Staff Report

Subject: 384 Sunfield Pl

Request for a fence in the front yard of a corner lot on the west side of Baxter Road, approximately 500 feet north of Greenmore Drive. This lot is considered a through lot, meaning it has road frontage along both the front and rear property line. The petitioner is requesting approval of a new fence on the property, along the rear property line.

SURVEYOR'S REAL PROPERTY REPORT LOT 44 OF COUNTRY GREEN ST. LOUIS COUNTY, MISSOURI

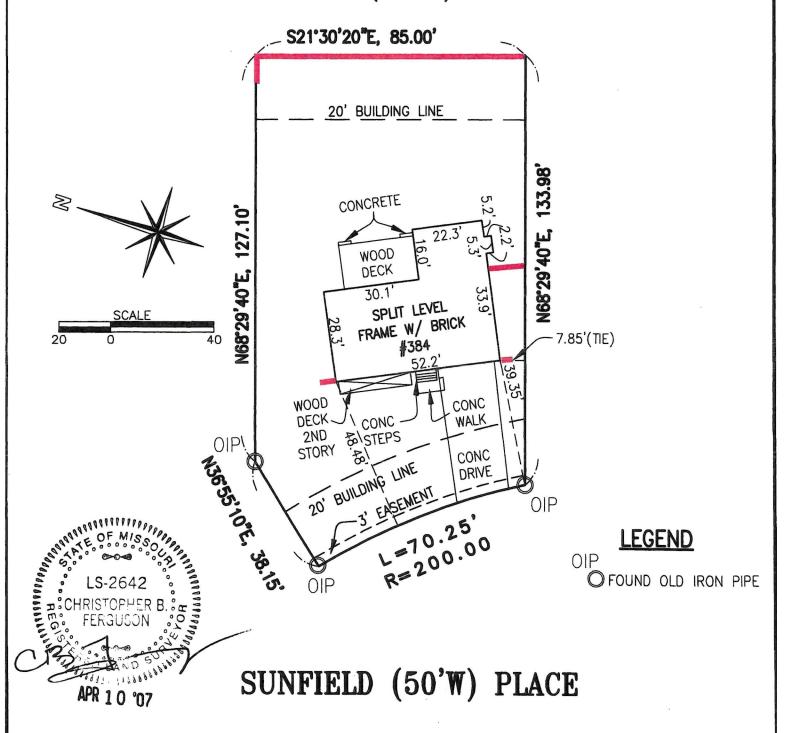
Currently, there is a chain link fence installed at the proposed location. The proposed fence would be a six foot (6') tall wood privacy fence, consistent with the neighboring fence. It complies with the necessary requirements and does not obstruct sight distance for drivers at the intersection. Staff recommends approval with the property owner's agreement to the stated requirements above.
